DRAINAGE SUMMARY

PROJECT: MAUNALOA HIGHWAY, REPLACEMENT OF CULVERTS BETWEEN
MAUNALOA VILLAGE AND KAUNAKAKAI - PHASE II
PROJECT NO. RS-0460(3)

STATE OF HAWAII
DEPARTMENT OF TRANSPORTATION
HIGHWAYS DIVISION

Replacement of Culverts bet. Maunaloa
Village and Kaunakakai - Phase II

DETAILS OF NEW 60" CULVERT AT STA. 72+64

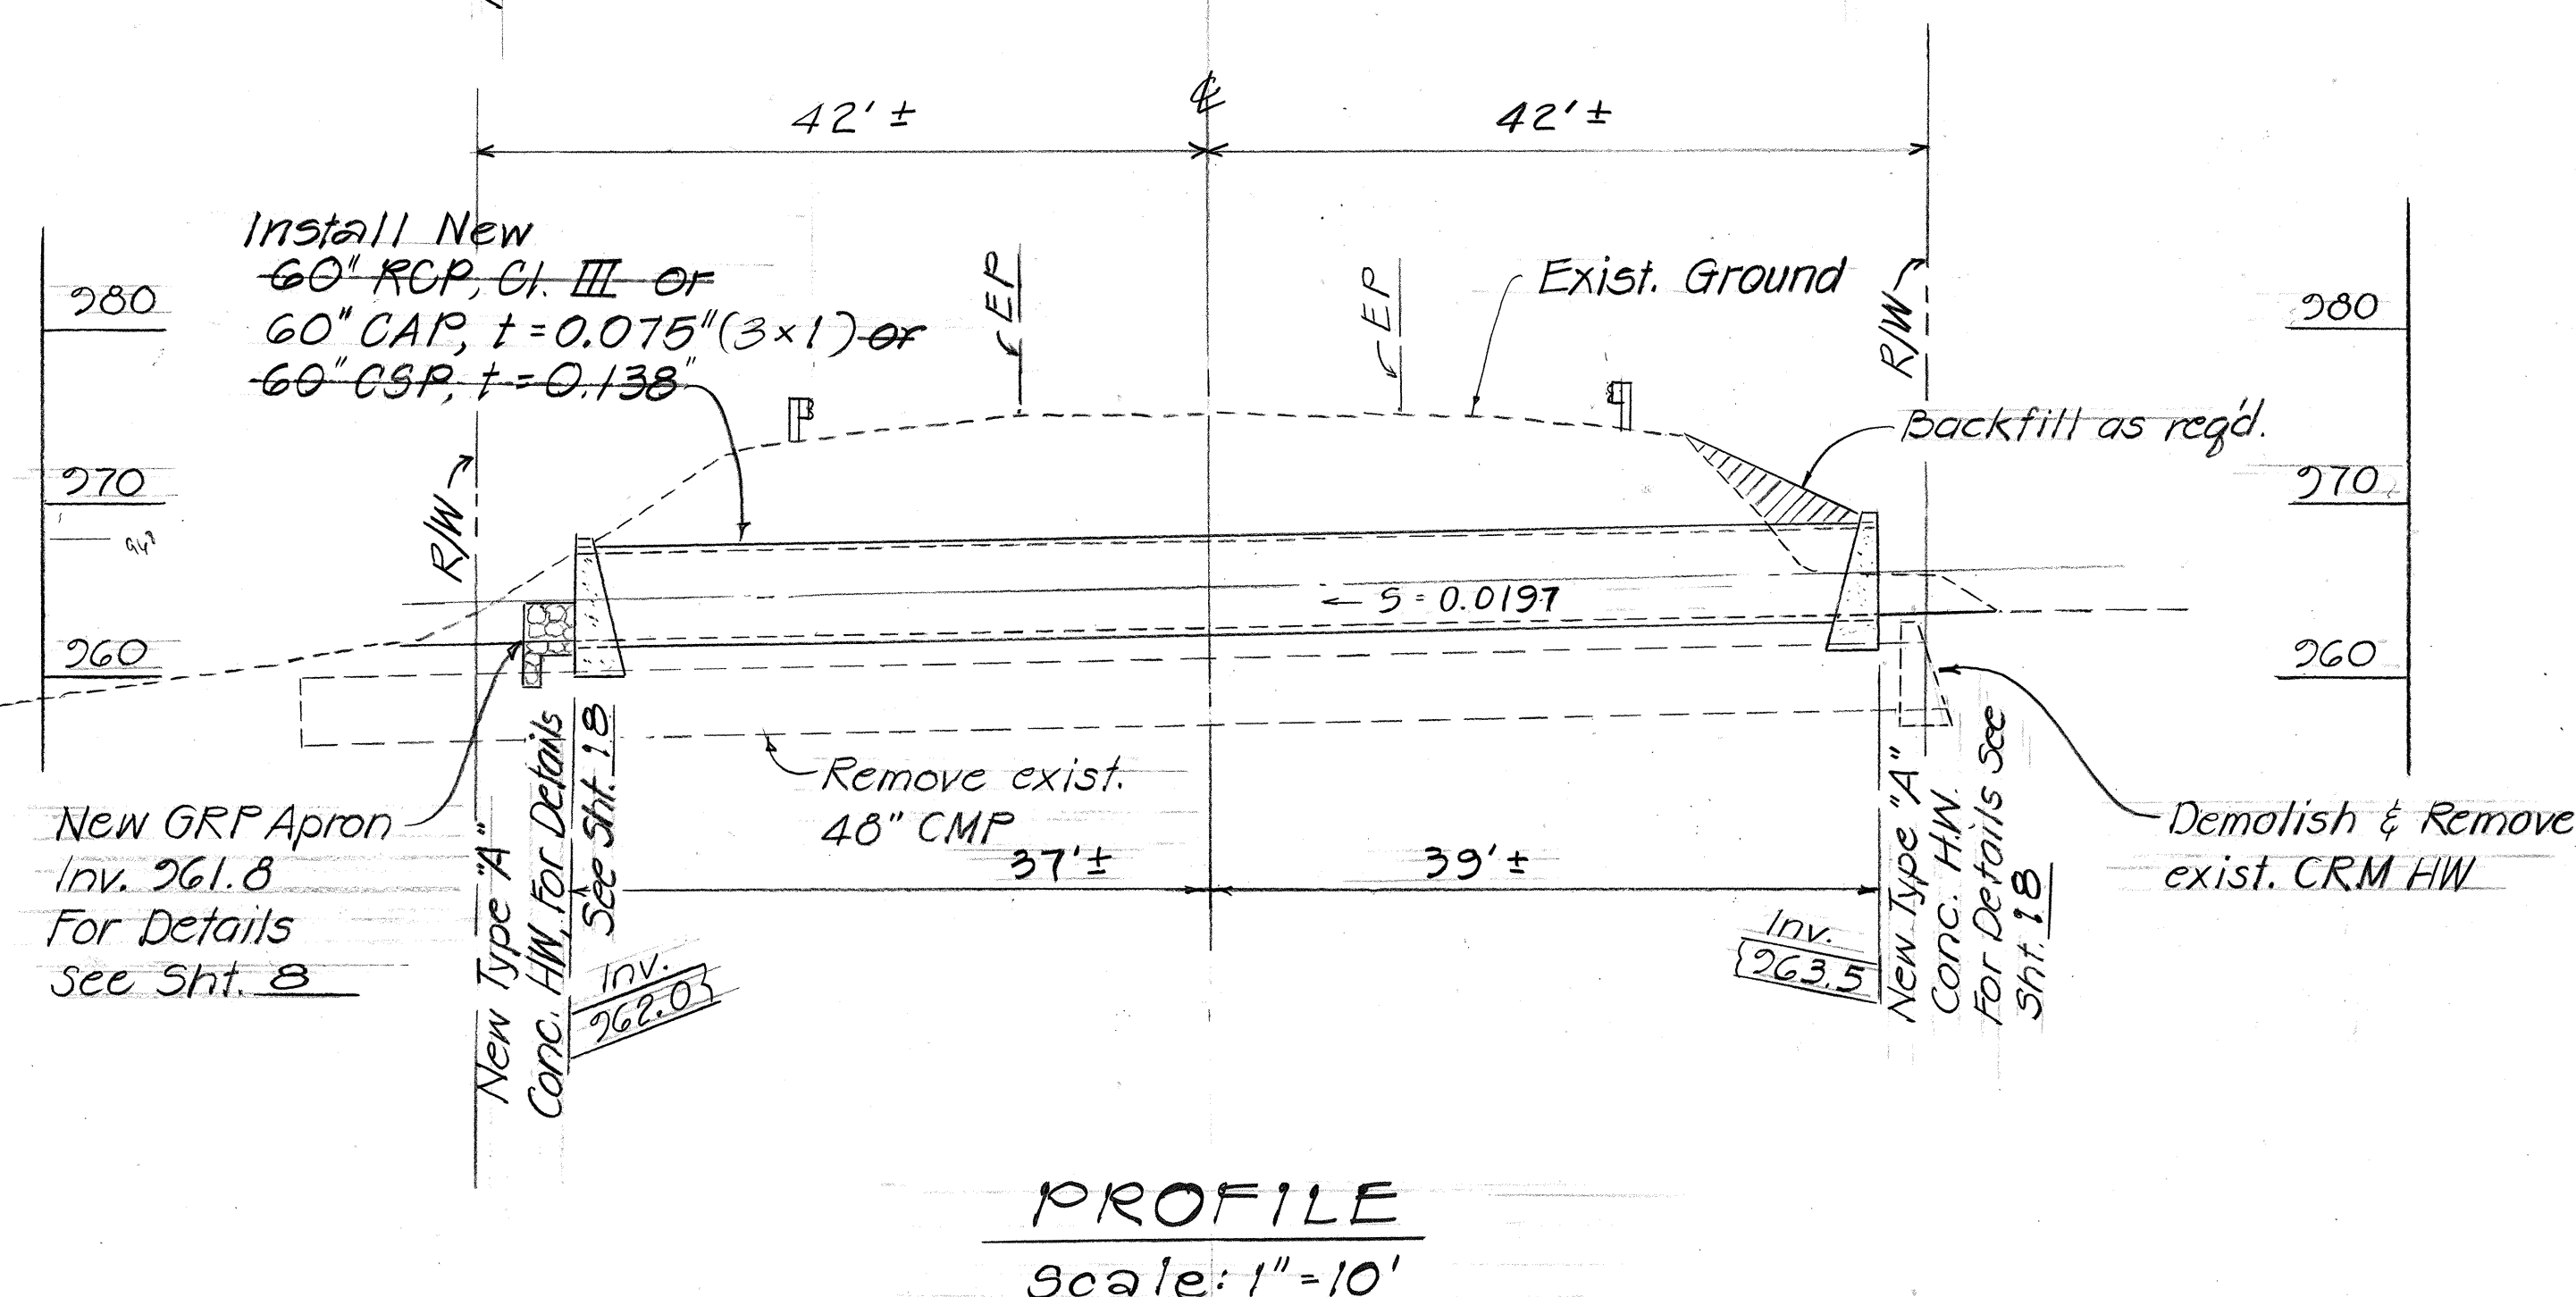
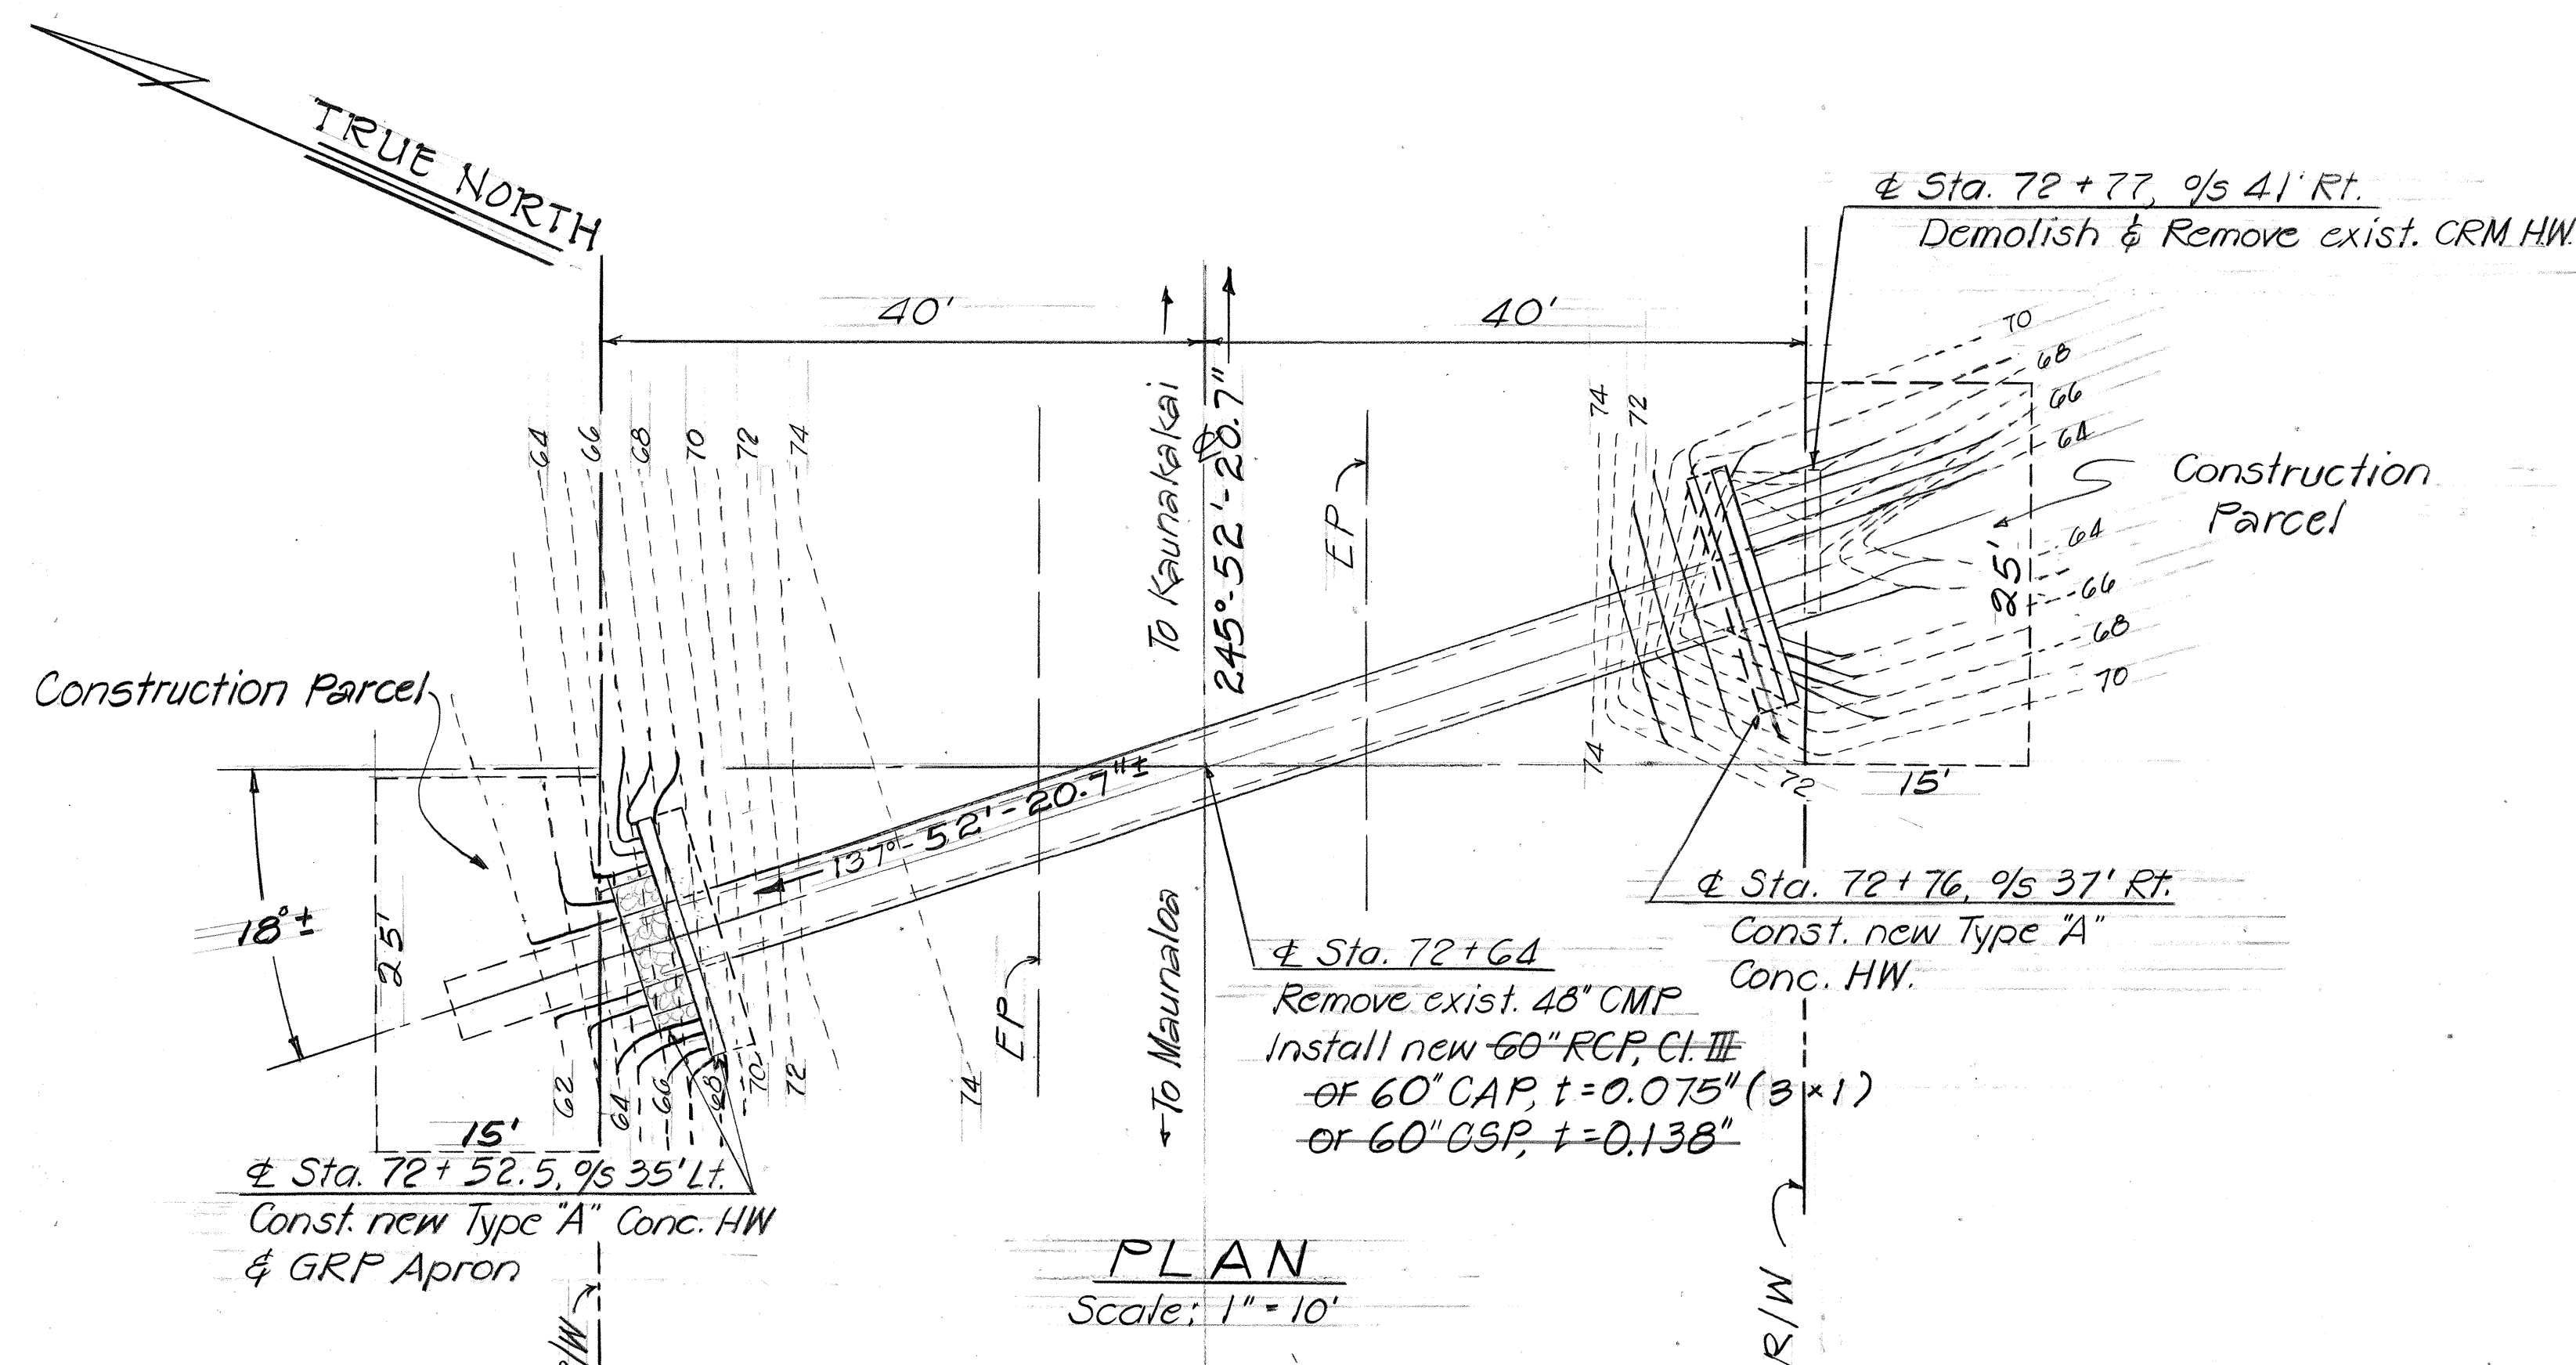
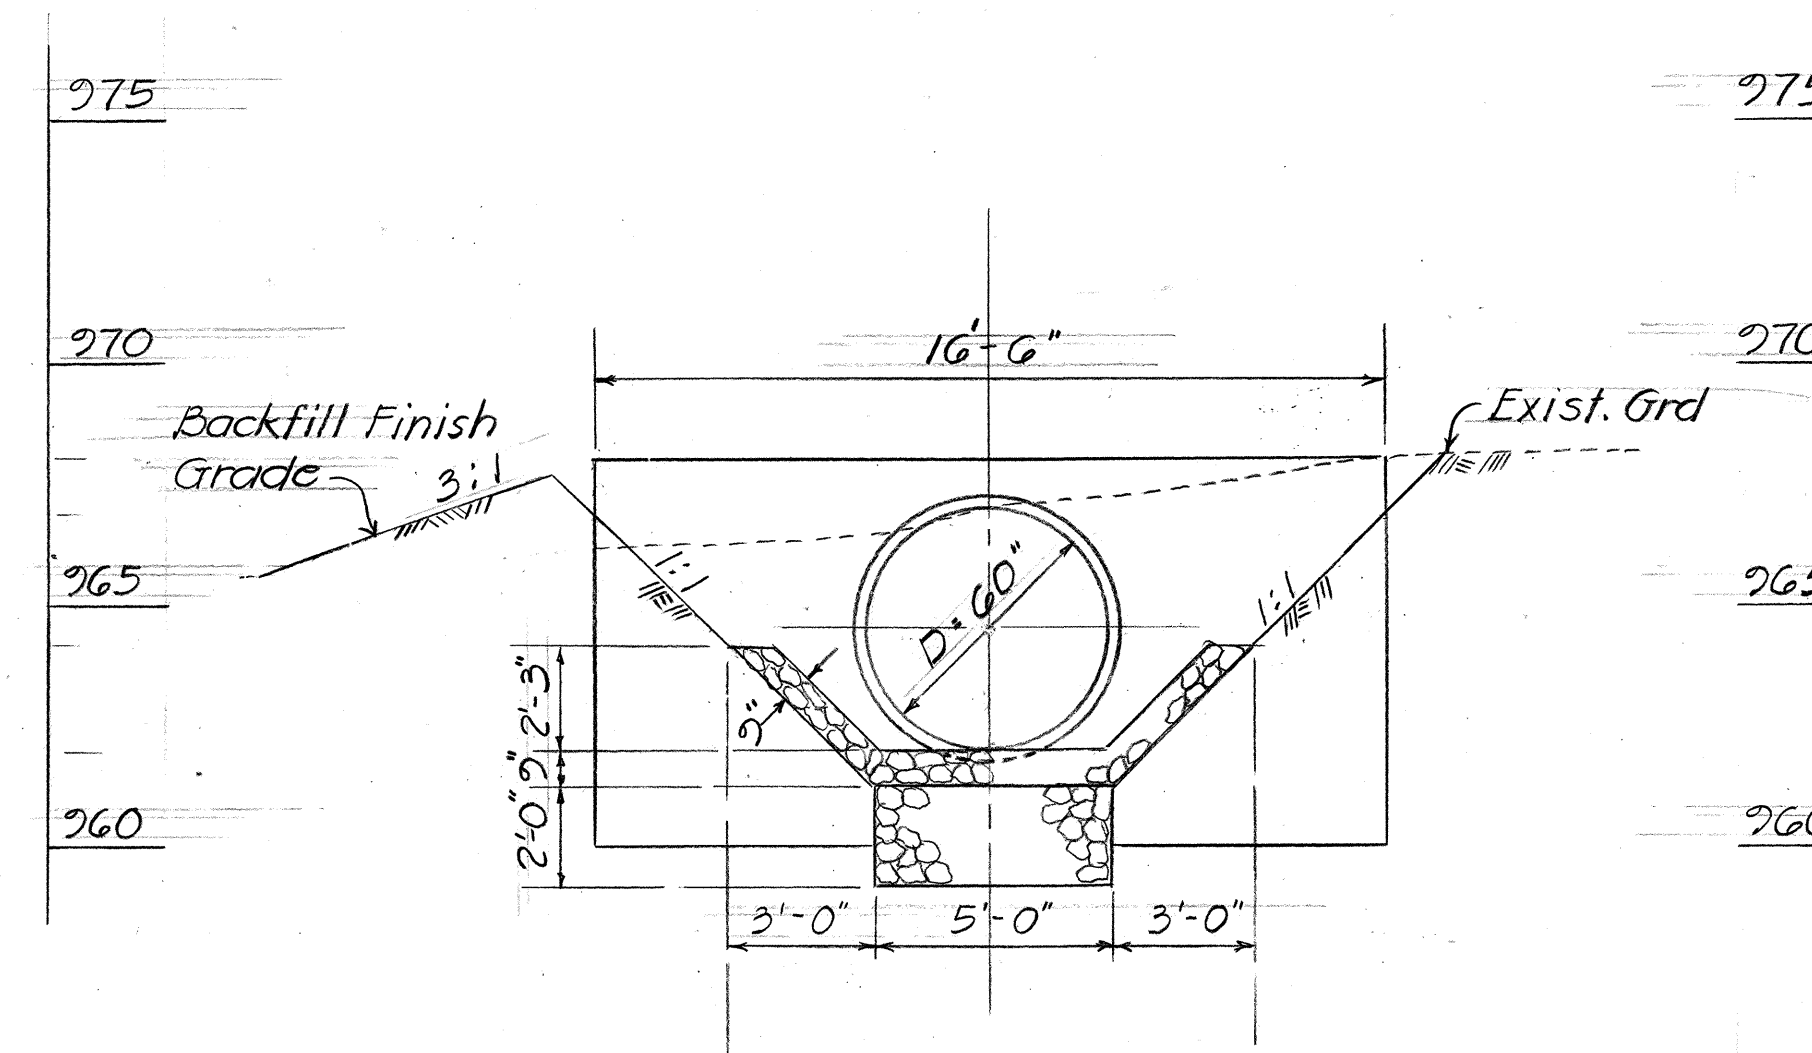
10/23/84	Per Addendum No. 1 Changed 60" CAP, t=0.135" to 60" CAP, t=0.075" (3x1)
DATE	REVISION
